04	07.02.19	Lights added/deleted/moved as per client comments, see revision clouds; LED strip incorporated on handrails, see revision clouds; bottom grilles have moved down, see revision clouds; MJ amended as per Client and Structural Engineer comments. Notes added on MJ in order to clarify real position; Brick Joints/Wall Lamps/RWP plates have been incorporated on Balconies; Key and Notes have been updated, see revision clouds.	AO
03	12.12.18	Movement joints added as per Walsh drawings; Sliding doors into balconies revised as per client change; General updates in line with updates on external openings.	AO
02	16.02.18	General updates as per revision clouds, material key added to the elevations.	GF
01	13.10.17	Stage 04 Main Building Submission	GF
-	17.05.17	Stage 03 Main Building Pack	GF
REV	DATE	NOTES	INT

JOB TITLE
 Stanley Sidings, 101 Camley Street, Camden

DRAWING TITLE / LOCATION
 North Block Envelope - Lower Levels

DRAWN BY	CHECKED	SCALE	STATUS
GFV	DMV	1:100@A1 / 1:200@A3	STAGE 05
PROJECT	DRAWING NO	REVISION	
16022	N AL 0020 006	04

06 - South Block Lower level Elevation (Behind colonnade-opposite side)

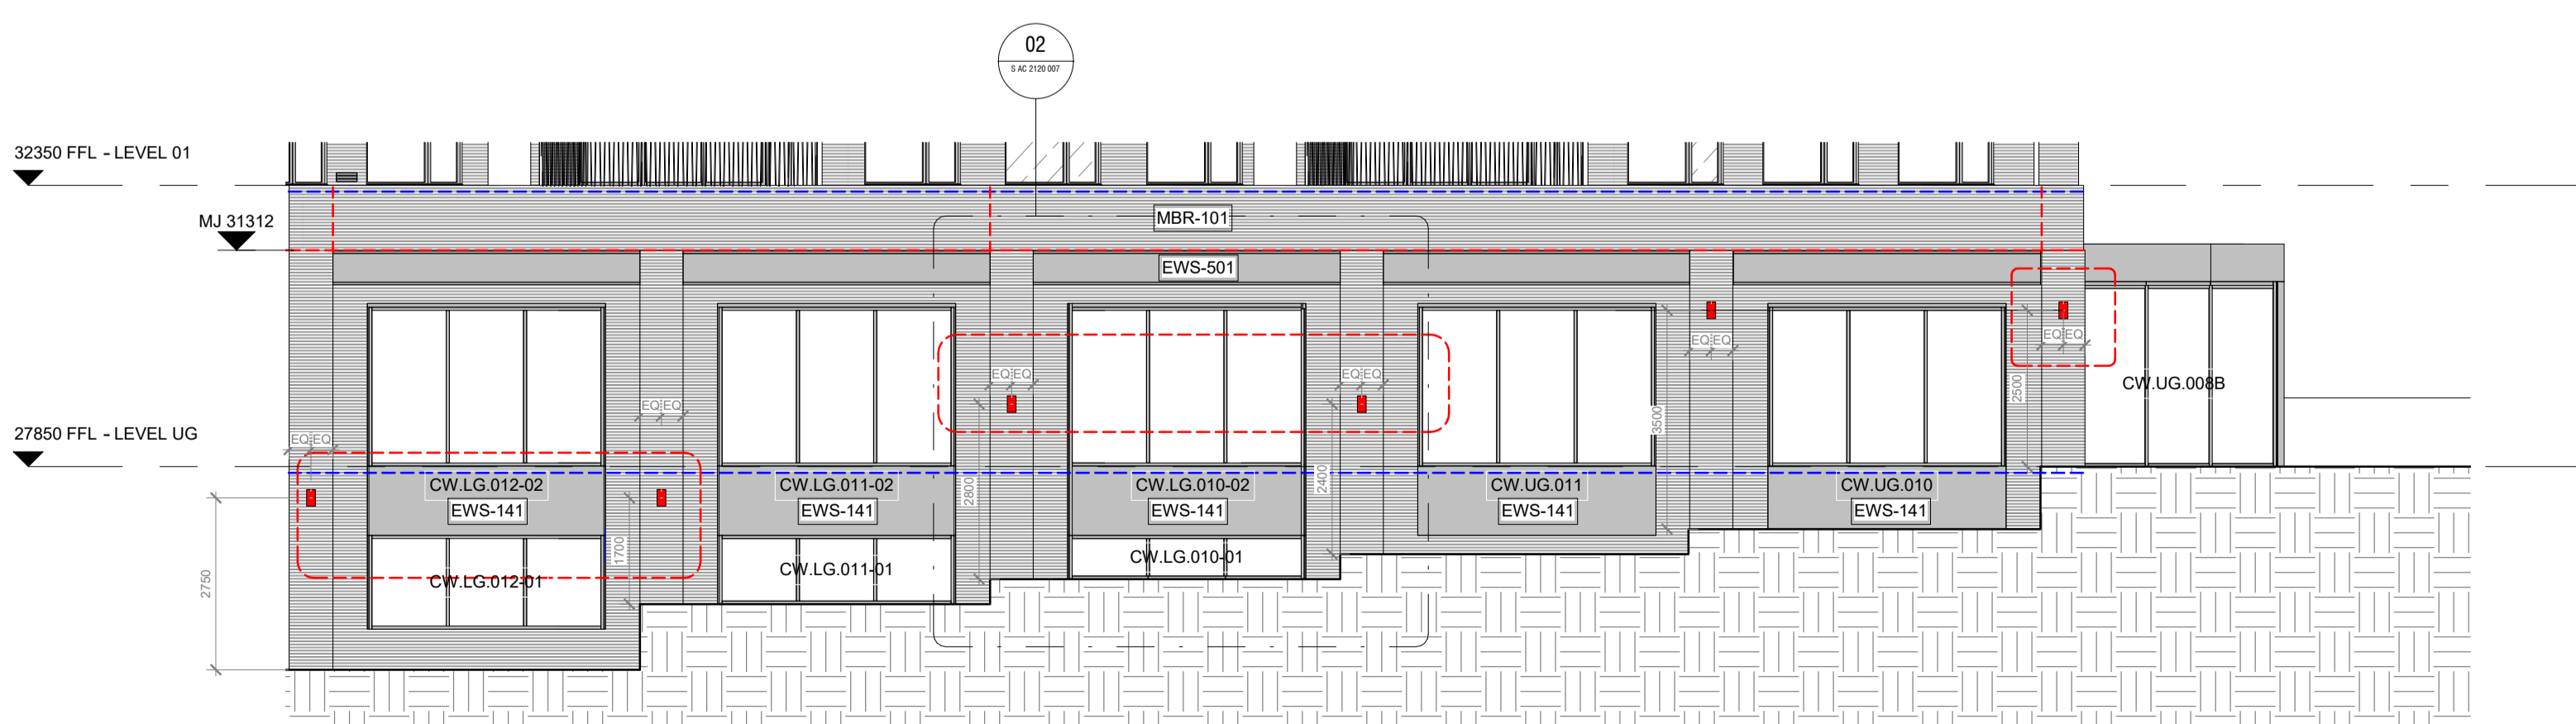
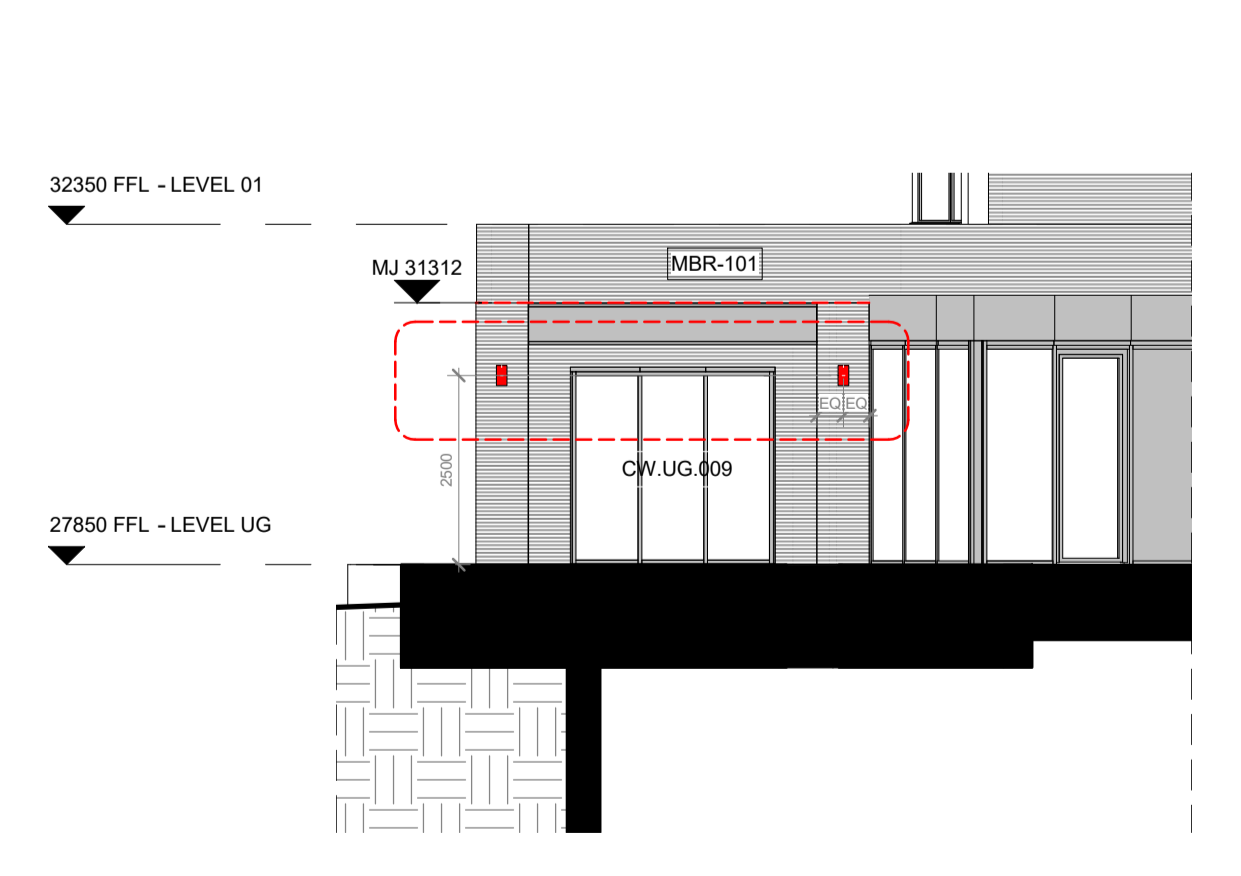
04	07.02.19	Lights added/deleted/moved as per client comments, see revision clouds; LED strip incorporated on handrails, see revision clouds; bottom grilles have moved down, see revision clouds; MJ amended as per Client and Structural Engineer comments. Notes added on MJ in order to clarify real position; Brick Joints/Wall Lamps/RWP plates have been incorporated on Balconies; Key and Notes have been updated, see revision clouds.	AO
03	12.12.18	Movement joints added as per Walsh drawings; Sliding doors into balconies revised as per client change; General updates in line with updates on external openings.	AO
02	16.02.18	General updates as per revision clouds, material key added to the elevations.	GF
01	13.10.17	Stage 04 Main Building Submission	GF
-	17.05.17	Stage 03 Main Building Pack	GF
REV	DATE	NOTES	INT

DRAWN BY	CHECKED	SCALE	STATUS
MH	DMV	1:100@A1 / 1:200@A3	STAGE 05
PROJECT	DRAWING NO	REVISION	
16022	S AL 0020 001	04

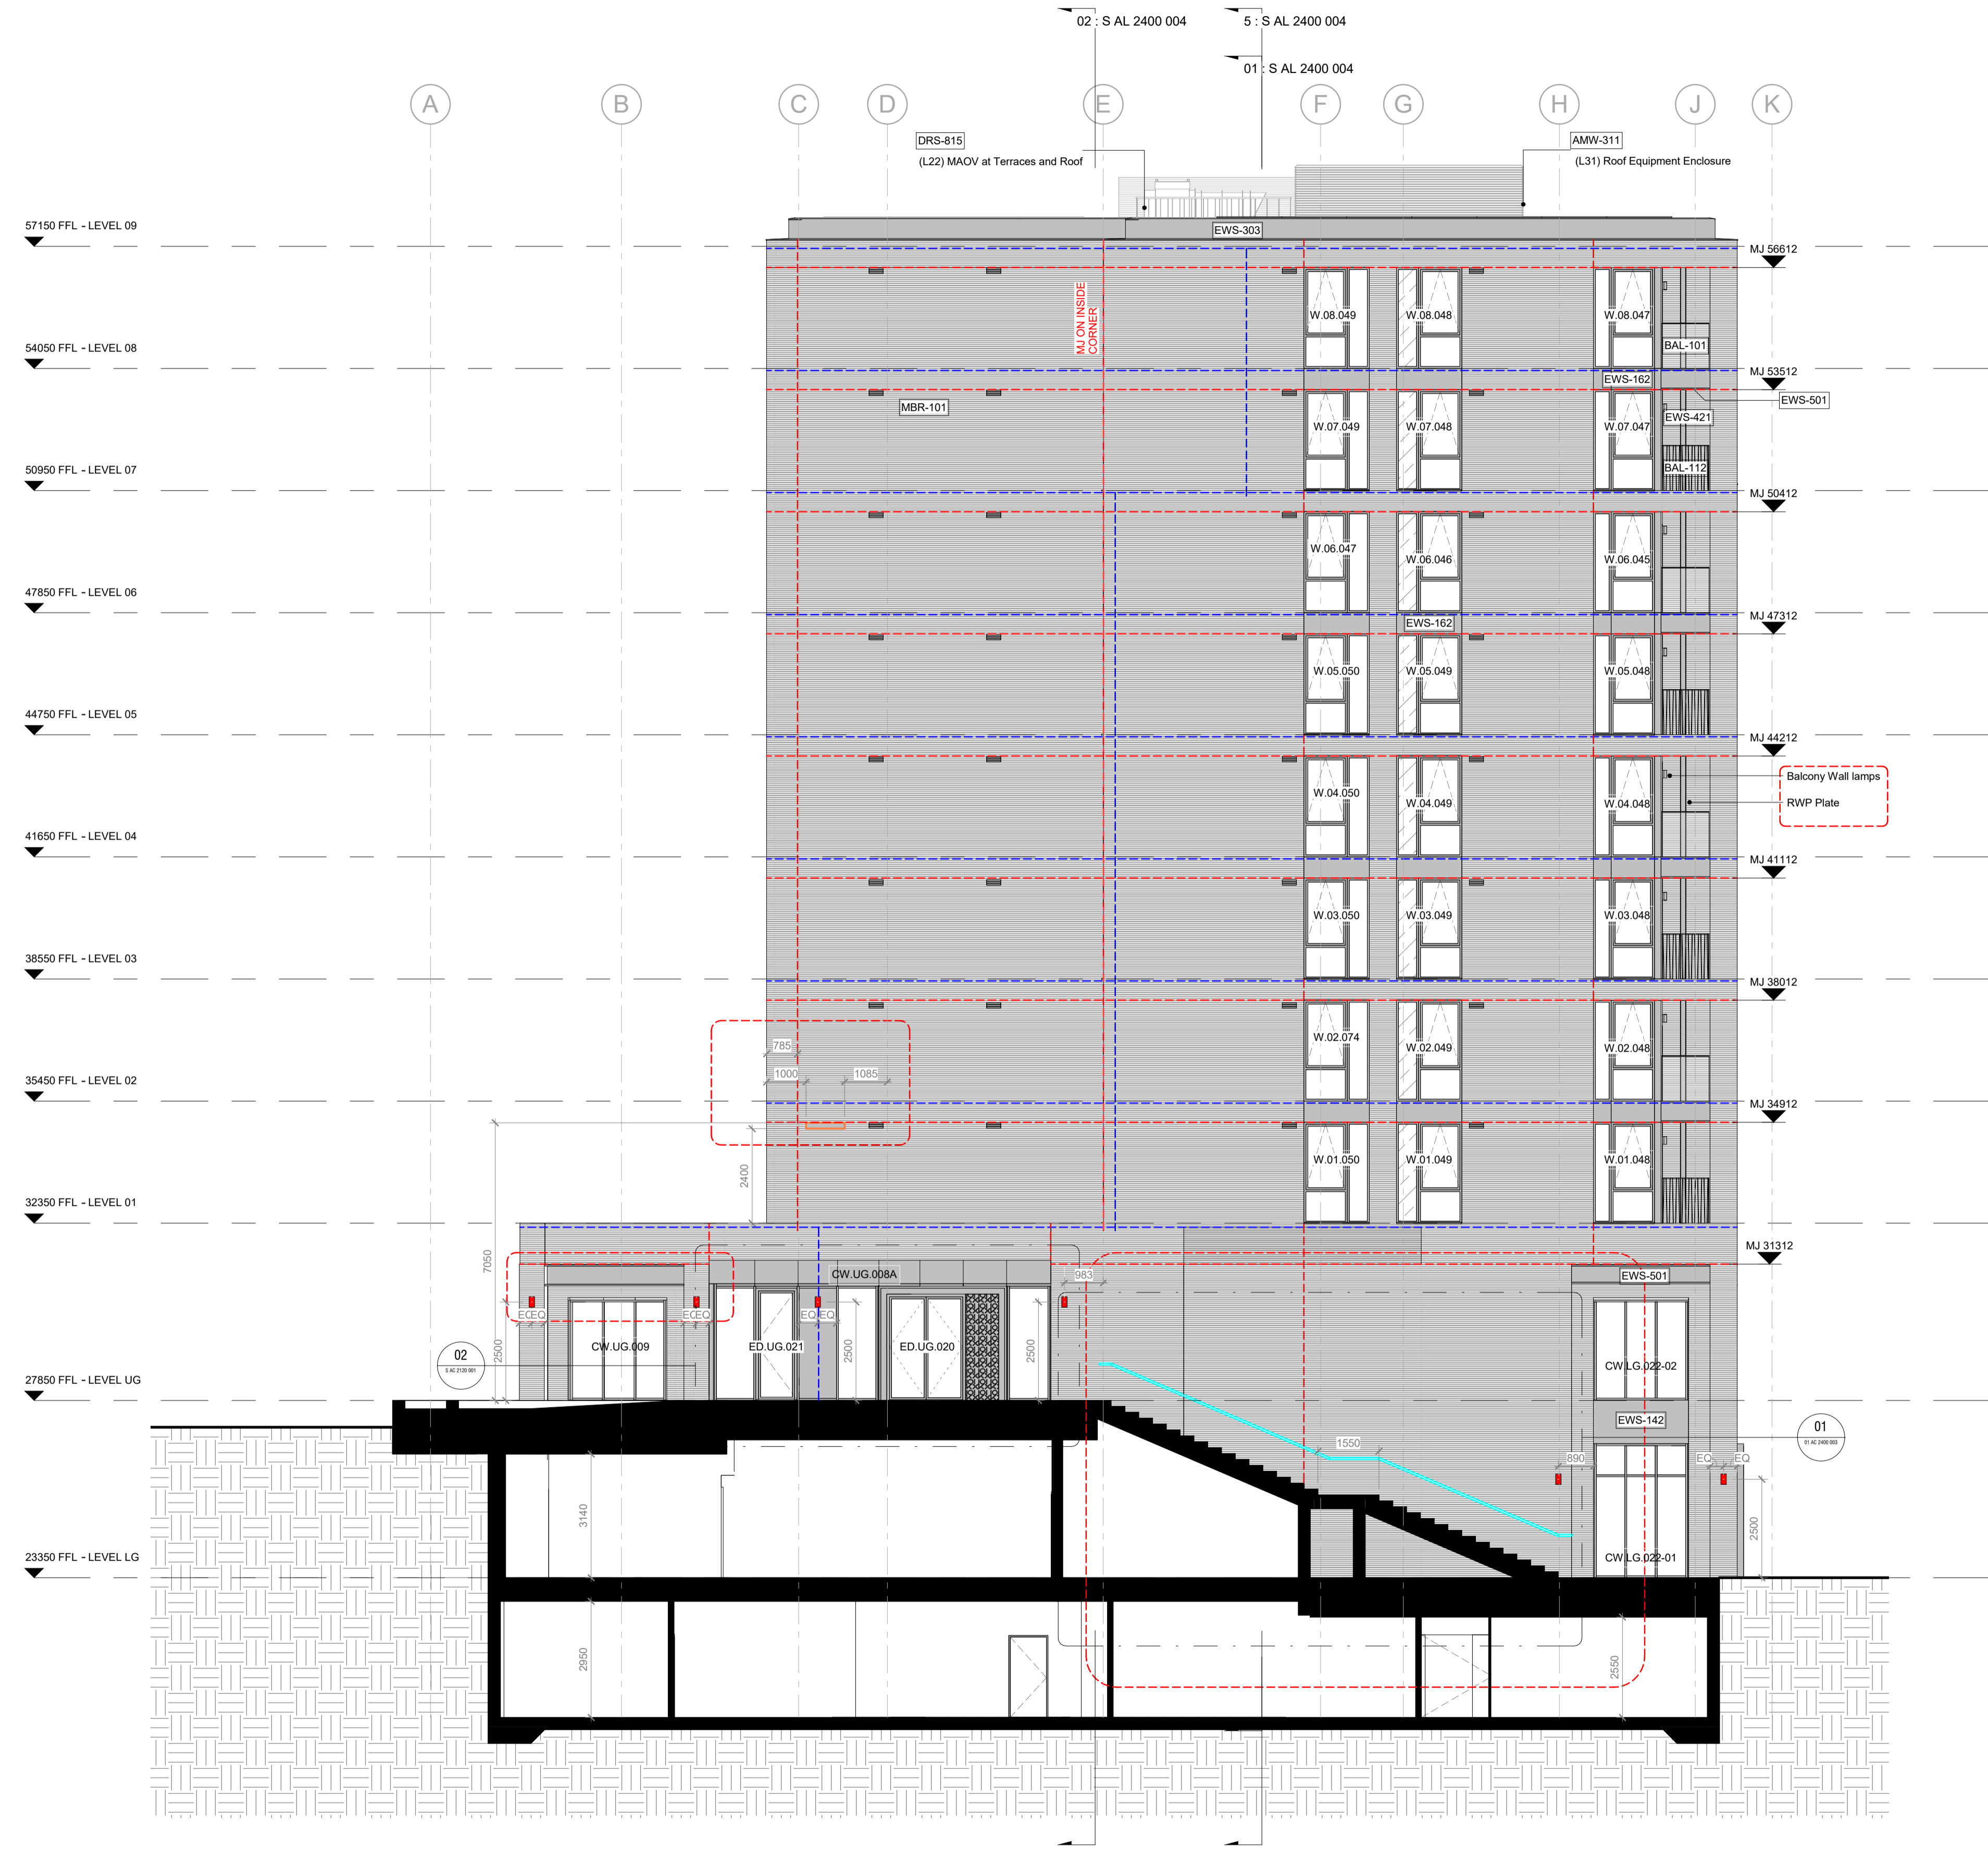
REV	DATE	NOTES	INT
04	07.02.19	Lights added/deleted/moved as per client comments, see revision clouds; LED strip incorporated on handrails, see revision clouds; bottom grilles have moved down, see revision clouds; MJ amended as per Client and Structural Engineer comments. Notes added on MJ in order to clarify real position; Brick Joints/Wall Lamps/RWP plates have been incorporated on Balconies; Key and Notes have been updated, see revision clouds.	AO
03	12.12.18	Movement joints added as per Walsh drawings; Sliding doors into balconies revised as per client change. General updates in line with updates on external openings.	AO
02	16.02.18	General updates as per revision clouds, material key added to the elevations.	GF
01	13.10.17	Stage 04 Main Building Submission	GF
-	17.05.17	Stage 03 Main Building Pack	GF
